Re: 07ITB56429K-RS Freemanville Road Water Main Replacement

Addendum No. 3

FREEMANVILLE ROAD
WATER MAIN

PROJECT NO:	02016029
DATE:	JULY 2007
SCALE:	NTS
ADDENDUM NO.:	3
SHEET REVISED:	24
SKETCH NO.	1

PIPE BEDDING & HAUNCHING DETAILS

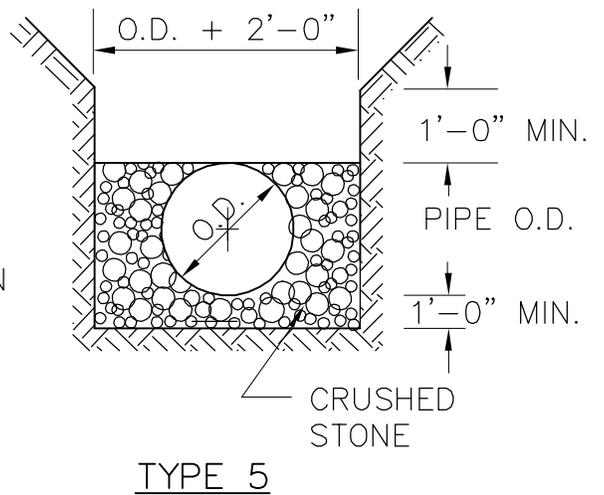
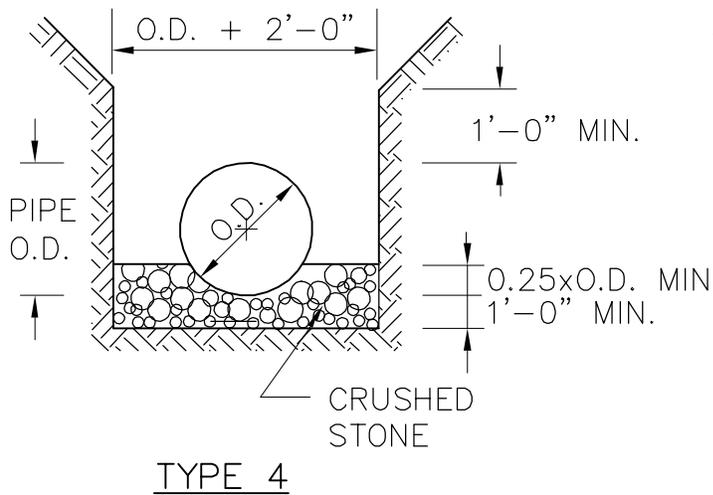
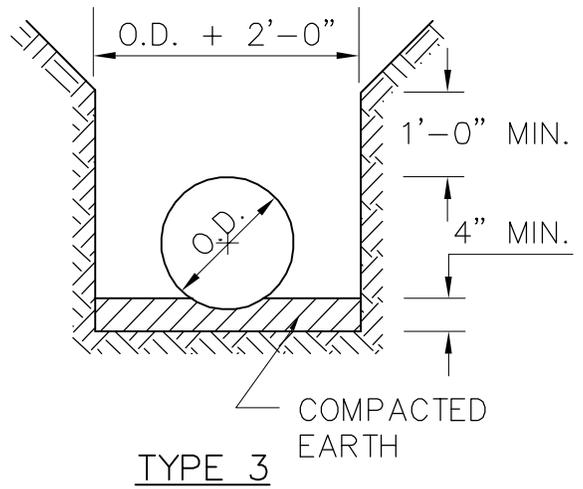
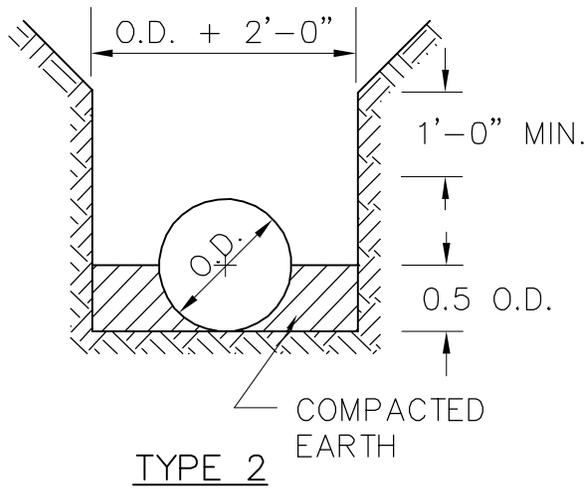
Item 12 Sheet 24, add PIPE BEDDING AND HAUNCHING DETAILS as shown on Sketch 1, included with this addendum.

ASPHALT REPLACEMENT DETAIL

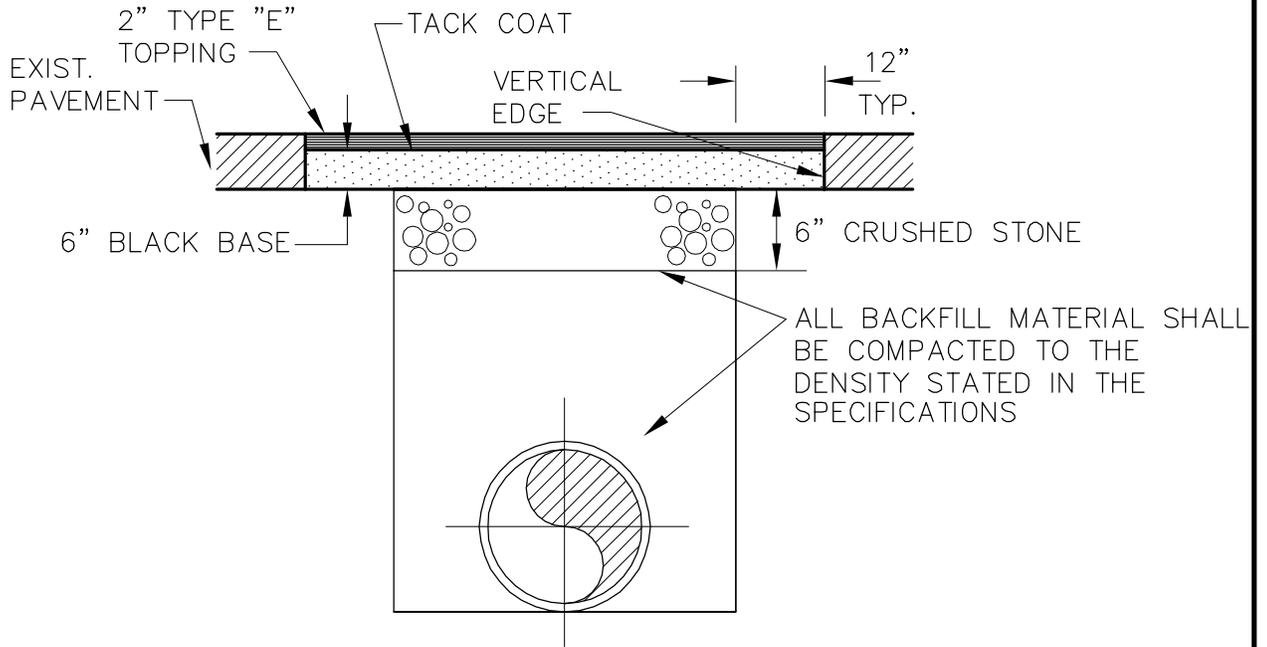
Item 13 Sheet 24, add ASPHALT and CONCRETE REPLACEMENT DETAILS as shown on Sketch 2, included with this addendum.
